SERVICE BULLETIN 240E

SUBJECT: Inspection of Propeller Blade for Cracking

MODEL AFFECTED: 1A170E/JHA[XXXX], See Compliance: for Specific Serial Numbers

Service Bulletin 240E replaces the original issue and previous revisions of SB240 in their entirety. Service Bulletin 240E changes the logbook entry in Section III, Step G. Lines in the margins indicate changes.

Figure 2

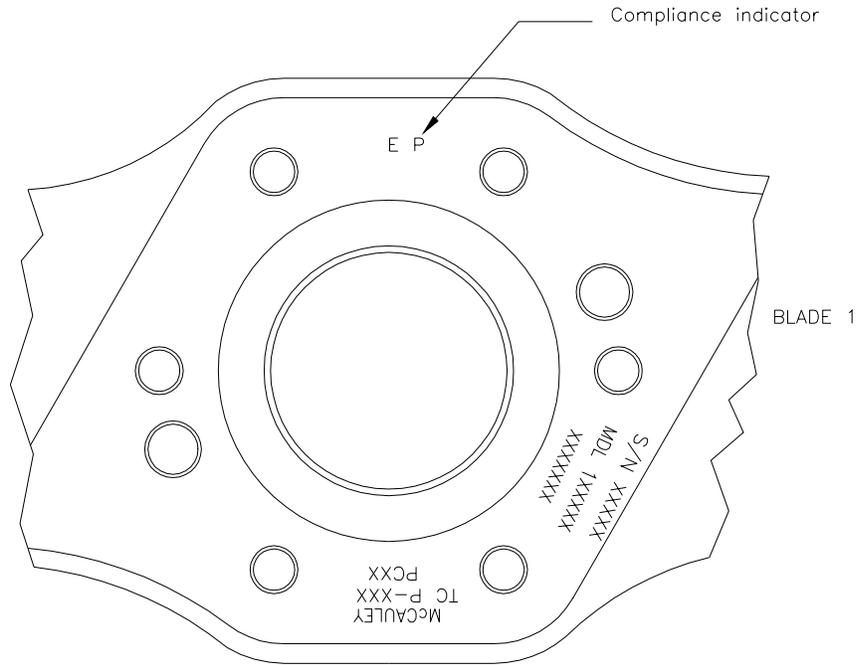
G. Stamp propeller hub with compliance indicator "P" at initial inspection per Figure 2 using 0.125 inch (3.18 mm) round bottom steel stamp. Stamp applicable number after letter "P" to indicate second ("2") and additional ("3", "4" etc.) inspections. Compliance indicator is to be stamped 180° from "McCauley" stamping. Propeller may have previous compliance indicator "E" stamped on the hub, stamp new indicator after the "E", if present.
